# Lake George Mine Remediation

Addendum REF

Department of Regional NSW

16 December 2022

**FIGURE 2.1**

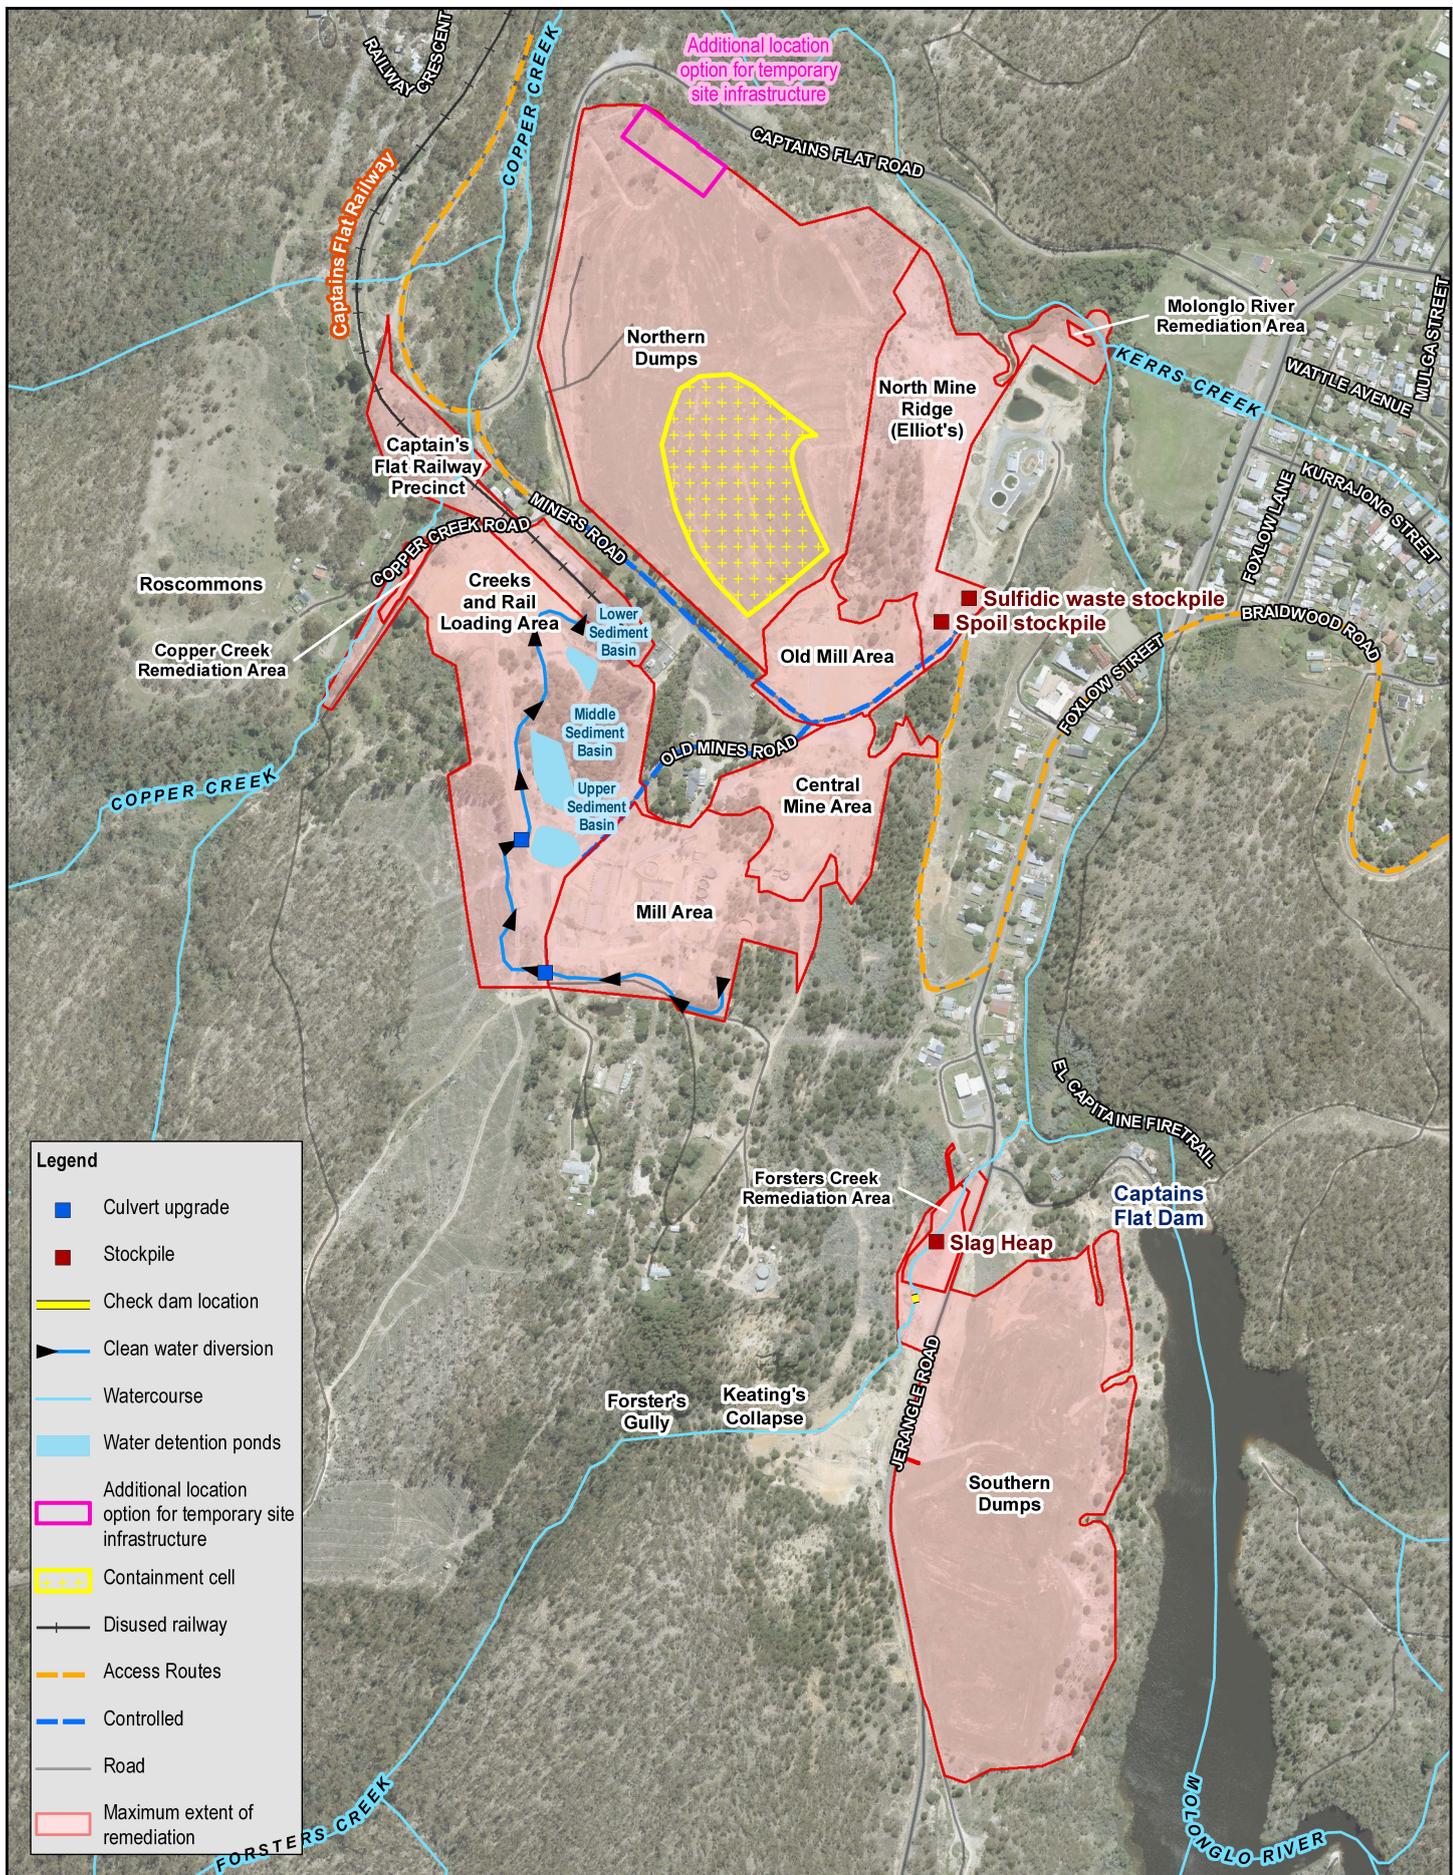
Figure 2.1 shows the revised maximum extent of remediation, noting that the boundary for the Captains Flat Railway Precinct remains as assessed in the original REF.

The modified site boundary accommodates:

- the clean water diversion drain and sediment basins in the Creeks and Rail Loading Area and Mill Area
- the additional location option for the temporary site infrastructure
- the remedial work in and around Copper and Forsters Creeks and the Molonglo River (i.e., a controlled activity (remedial works) on waterfront land as defined under the NSW *Water Management Act 2000*)
- minor road maintenance works
- other minor refinements as required.

**FIGURE 2.2**

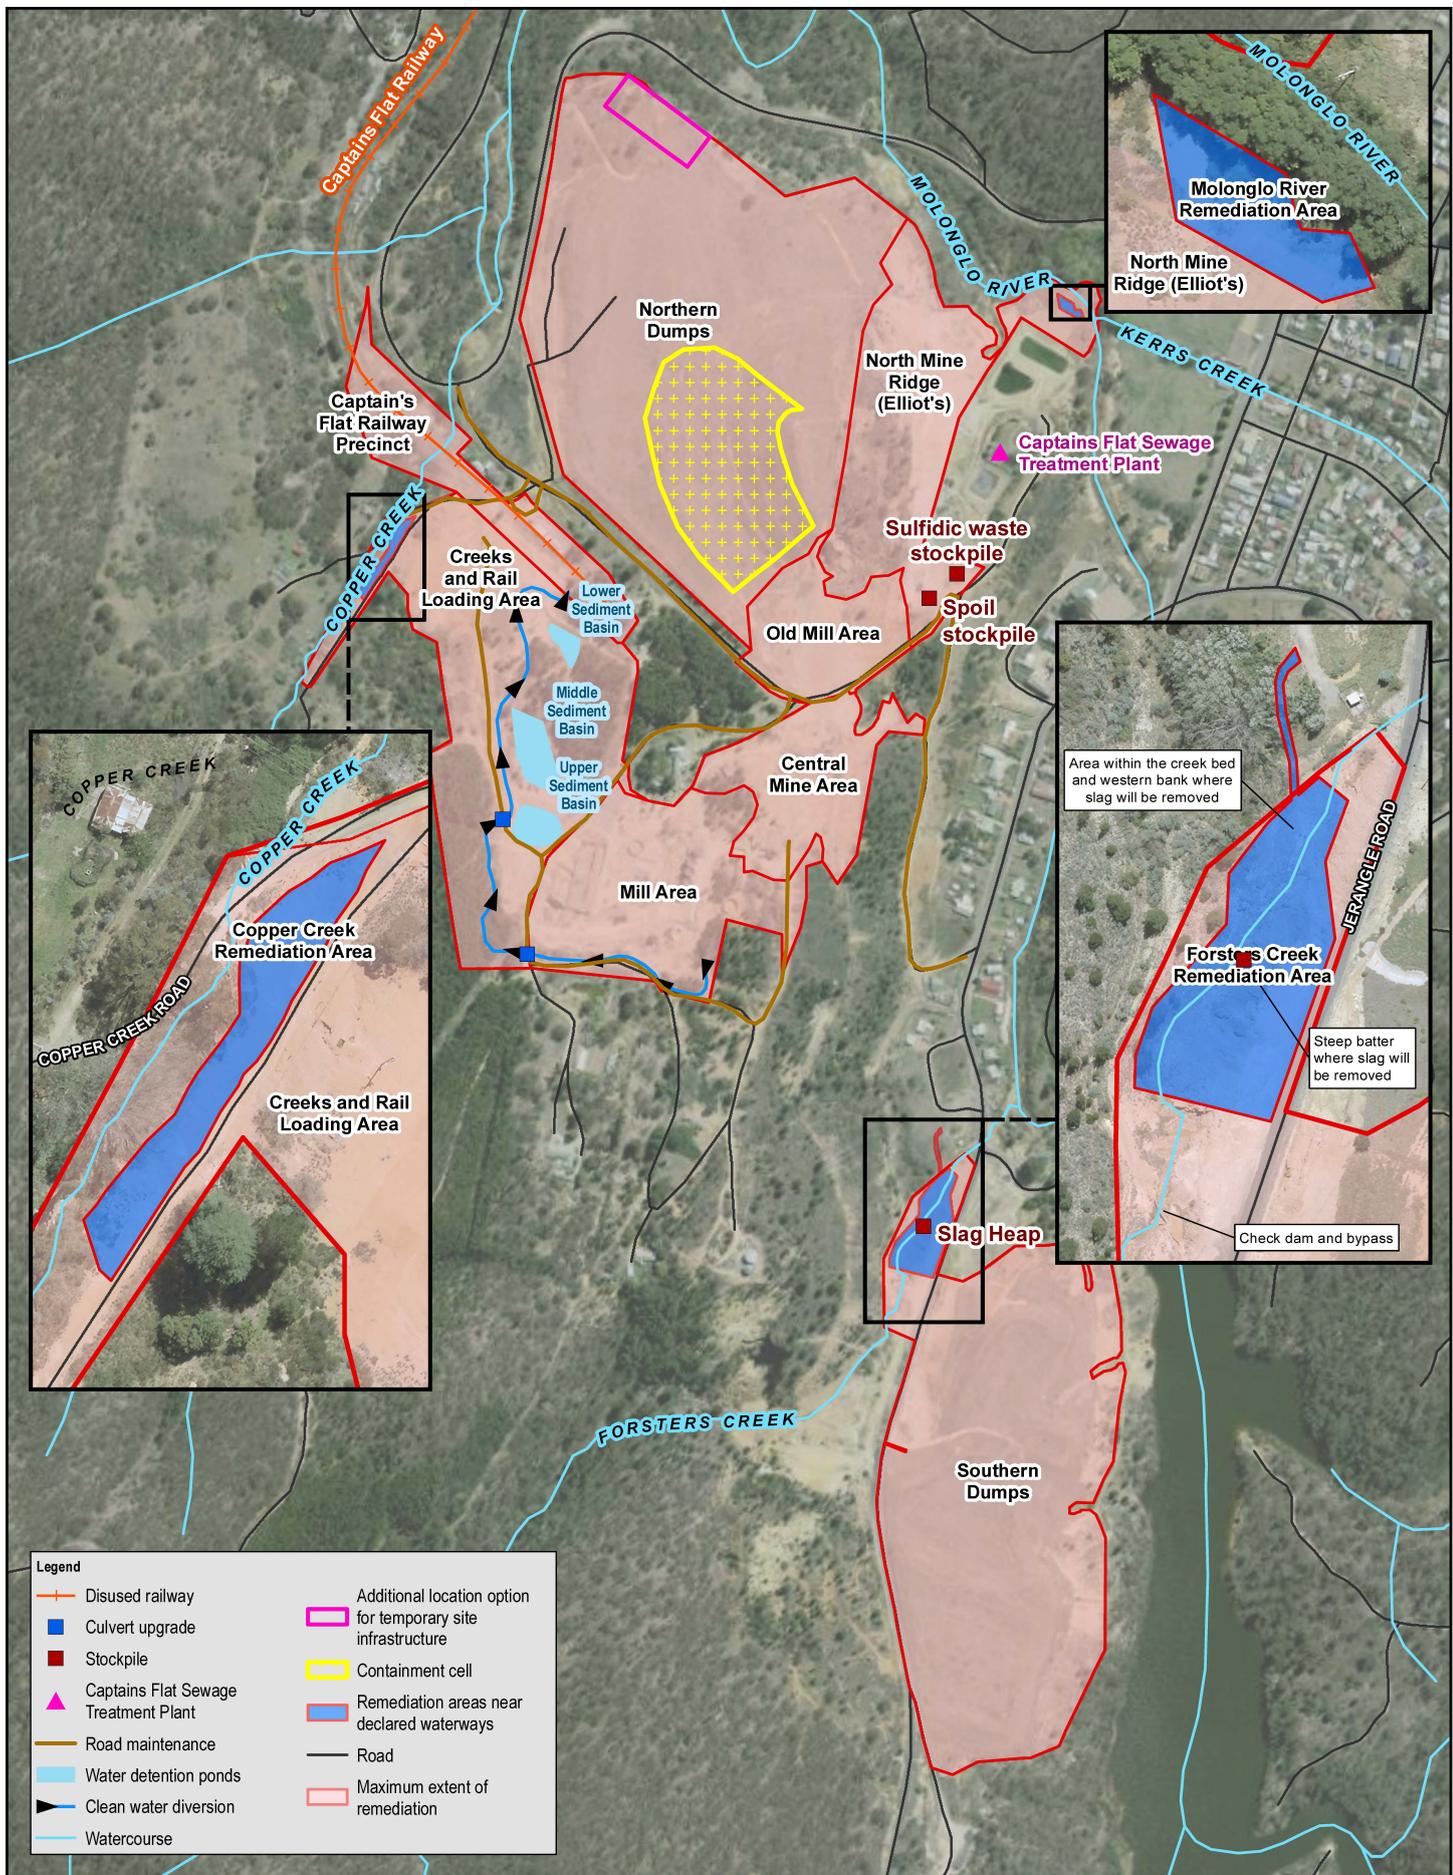
The amendment includes a third option for the location of the temporary site infrastructure, being at the northern extremity of the Northern Dumps, as shown in Figure 2.2. The temporary site infrastructure remains unchanged from the approved REF and includes a portable (demountable):

The approved project includes removal of a sulfidic waste stockpile in the North Mine Ridge/Elliot's domain (shown in Figure 2.2) and placement in the containment cell located on the Northern Dumps.

The amendment to the approved remedial strategy for the sulfidic waste stockpile is that the cleared stockpile footprint would optionally be backfilled to grade with material from an existing spoil stockpile located adjacent to the sulfidic waste stockpile (also shown in Figure 2.2).

FIGURE 2.3

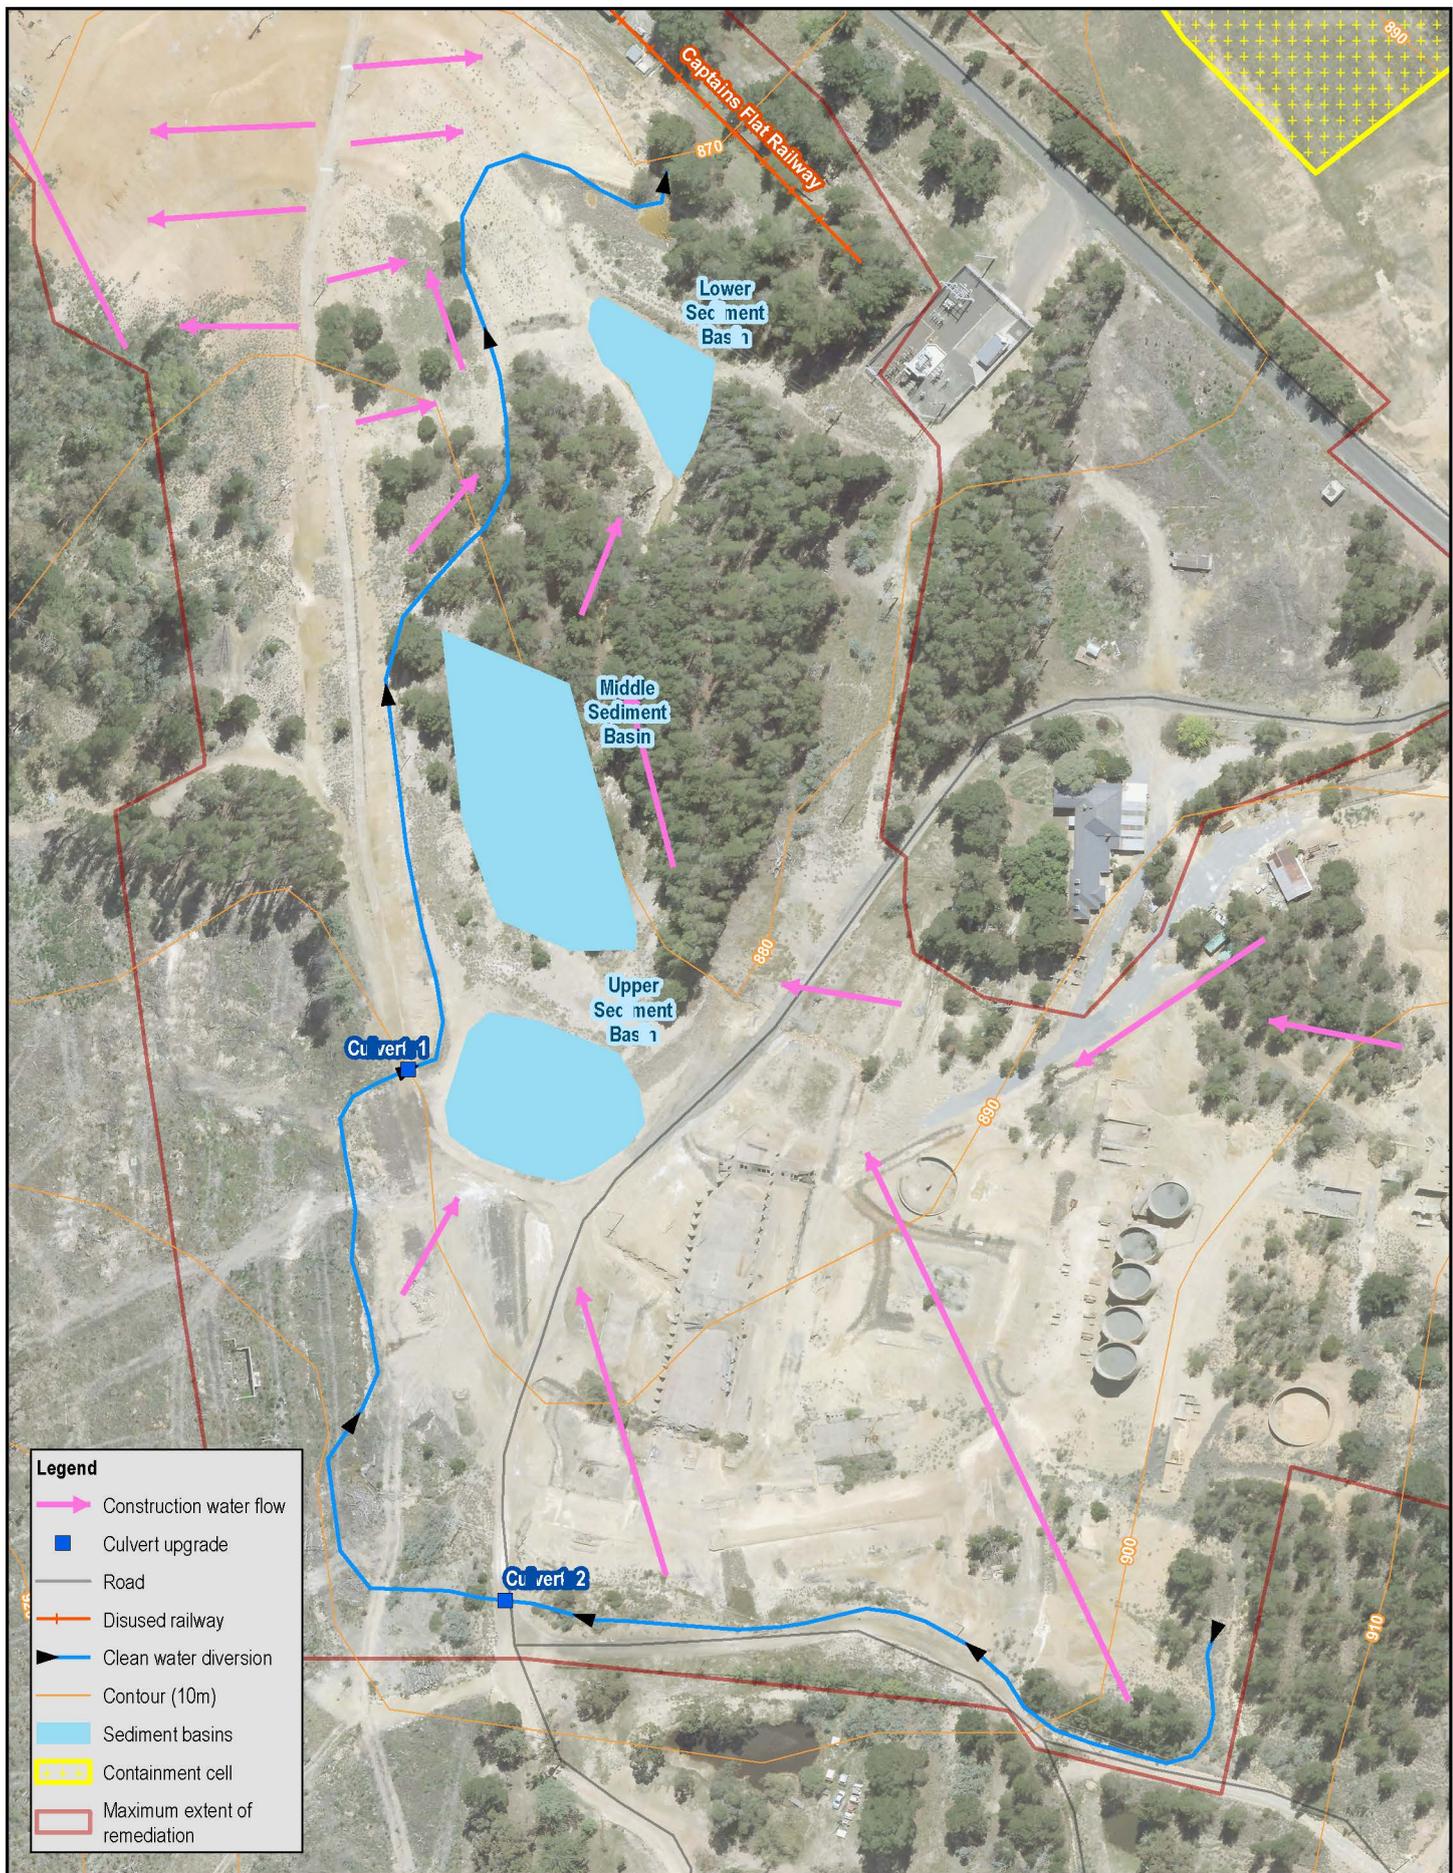
The remedial work in Copper Creek would involve excavation of contaminated material on the south-eastern bank as shown indicatively in Figure 2.3. Material would be removed from the unvegetated bank area between the track situated on the top of bank (i.e., the Crown road reserve) to approximately 800 mm above the baseflow channel, tying into stiff clay or rock. Placement of rip rap into the base flow channel would only be required where stiff clay or rock is not present in the base flow area. This would allow tie-in of the remediation work. Work would be undertaken nominally using a 20 tonne excavator or similar, stationed on, or adjacent to, the south-eastern bank of the creek, with the excavated material hauled to the contaminated cell using moxys or truck following amendment using lime or a lime alternative.

Further field inspections revealed that remediating the full extent of the slag within Forsters Creek would require access to the channel bed. As such, remedial works on waterfront land have been included in this modification, as shown indicatively in Figure 2.3.
